CDM: Response form for request for clarification on Approved Methodologies (version 01.1)

| <i>Title and number of request for clarification</i> | Verification of total energy supplied by the generator through summation of electricity received by the recipient plants. AM_CLA_0201 |

Figure 1

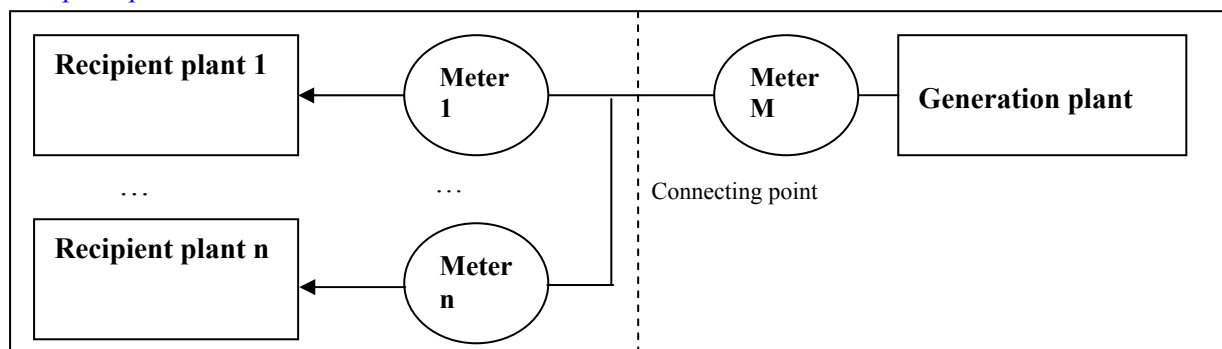
Situation-1: When the generator and recipient plant(s) are independent entities, two sets of meter(s) will be installed at the recipient plant and generation plant(s) respectively, and their readings can be used to cross check, as shown in Figure 1. However, under this circumstance, minor differences exist between the readings of two sets of meters due to the transmission loss.

In this case how can the following sentence be satisfied?

“DOE shall verify that total energy supplied by the generator is equal to total electricity received by the recipient plant”

Under **Situation-1**, it is important to keep in mind that baseline is only determined based on the energy received by the recipient. Therefore, it has to be determined based on the reading of meter 1 (or meter n) to be multiplied by baseline emission factor of respective recipients. What needs to be ensured is that the sum of electricity received by the recipients is not higher than the electricity supplied measured by meter M. In case the amount of electricity supplied is higher, the amount of electricity received could be used to calculate baseline emissions.

However it may happen that due to accuracy differences, the sum of the electricity measured by the recipient/s surpasses the reading of the meter at the supplier's end. In such a case, the reading of the supply side meter should be adopted as the final conservative value of electricity supplied to the recipient/s (and received by the recipient/s). In case of multiple recipients, the electricity consumption of each recipient should be recalculated proportionately, by multiplying proportions of electricity received (using recipient side meters) with the total value of electricity supplied (supply-side meter).

Figure 2

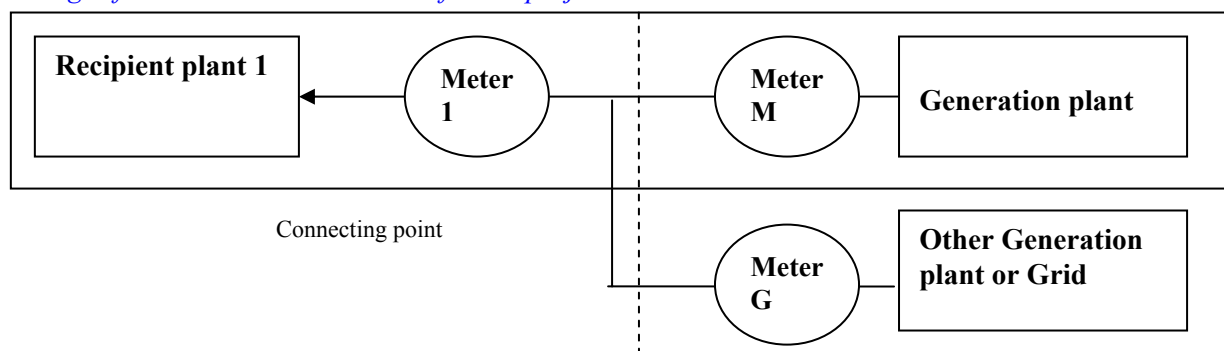
Situation-2: As shown in Figure 2 consider the following case. Consider that there are other power generation plant(s) or the grid which exist out of the project boundary (besides the power generation plant(s) of the project which is inside the project boundary), which supply electricity to the recipient plant. In this case the readings of meter M at the generation plant may be significantly smaller than meter 1 at the recipient plant if a great portion of the electricity used in the recipient plant is from the other generation plant or the Grid.

In this case, how shall the DOE verify the following sentence?

“ total energy supplied by the generator is equal to total electricity received by the recipient since the readings of meter G are not available for the project owner”

Under **Situation-2**, a separate meter has to be installed before the electricity from the grid or other generation is supplied in the same electrical line. The metering of electricity generated by the CDM project and received by recipient plant 1 has to be maintained separately from that supplied by any other source. Clarification provided for Situation-1 above also applies here.

Figure 3

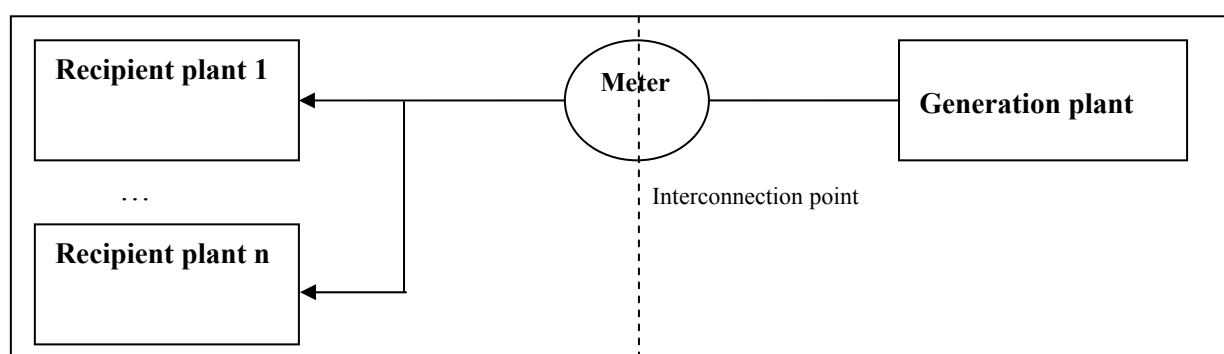
Situation-3: The recipient plant and the generation plant belong to the same owner and are in the same factory, the distance between the recipient plant and generation plant is short and the transmission line is directly connected from the generation plant to the recipient plant, the electricity output from the generation plant is directly supplied to the receipt plant through identified transmission lines. The situation is shown in Figure 3:

In this case, it is cost effective for the project owner to install only one dedicated meter at the interconnection point between the generation plant and the recipient plant at the transmission line.

Both the recipient plant and the generation plant will record readings of the same meter to cross check. Only under this circumstance can the DOE verify that the total energy supplied by the generator is exactly equal to the total electricity received by the recipient plant(s).

In this case, is it necessary for the PP to install two sets of meters measuring $EG_{j,y}$ at the recipient plant(s) and generation plant (s), respectively?

Under **Situation-3**, as the owner of the generation and recipient plant is the same (and not independent entities) and electricity is supplied within the same facility, a separate metering of electricity is not required for electricity generation and electricity received. Therefore one meter can suffice the requirement of monitoring of electricity as shown in Figure 3.
